UNITED STATES PATENT AND TRADEMARK OFFICE

APPLICATION NO.	FILING DATE	FIRST NAMED INVENTOR	ATTORNEY DOCKET NO.	CONFIRMATION NO.
09/733,036	12/11/2000	Kenji Yamauchi	249331/98DIV	2508

Office Action Summary

DETAILED ACTION

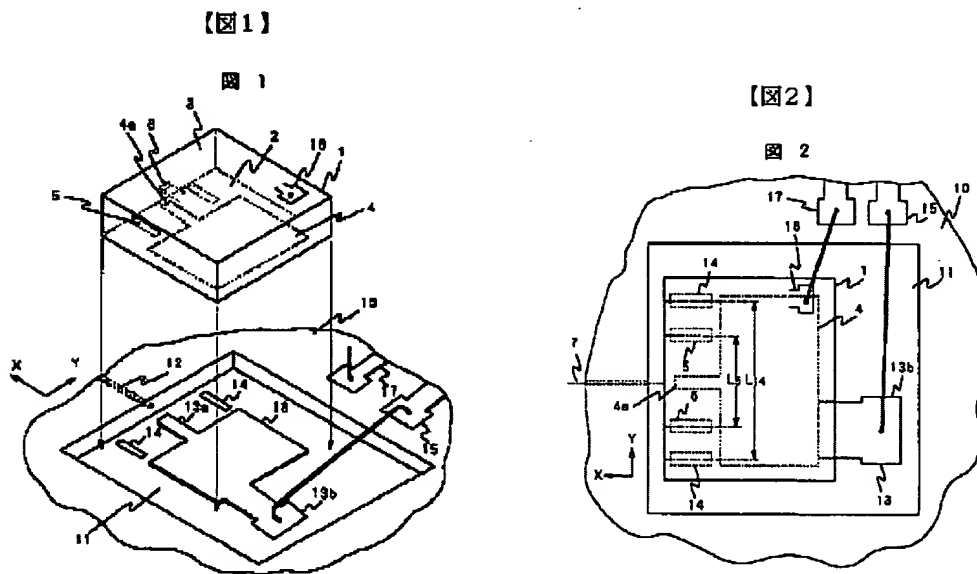
4. Claims 1-3, 21-23, 27-33 are rejected under 35 U.S.C. 102(b) as being anticipated by Sasaki et al (JP 09-145965 A). Sasaki et al discloses the claimed invention. Figure 1 illustrates a semiconductor laser chip comprising a first mark, a second mark.

Also note figure 2 which illustrates a first pair of marks (5) and a second pair of marks (14).
